TECHNICAL INFORMATION #928

ZIB-121

Re: Improvement of RF feedback for the IC706MK2G

Model: IC-706MK2G (All versions)

FILTER Board

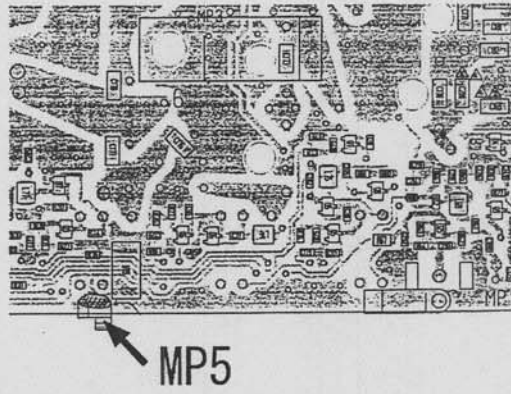
The RF feedback occurs when SWR condition get worse. This symptom appears on 18 and 21MHz bands mostly at the condition when the SWR is more than 2:1.

- 1) Add the following part on the FILTER board. (See the attached location.)

| Board | Parts Number | Parts Number (Old) | Parts Number (New) | Action Taken |
| FILTER | MP5 | None | 8930055970 | Added |
| | | | SPRING 2177 GND SPRING | |

- 2) Re-adjust the position of all ground springs on the PLL board, ensure the good ground contact between PCB and chassis.
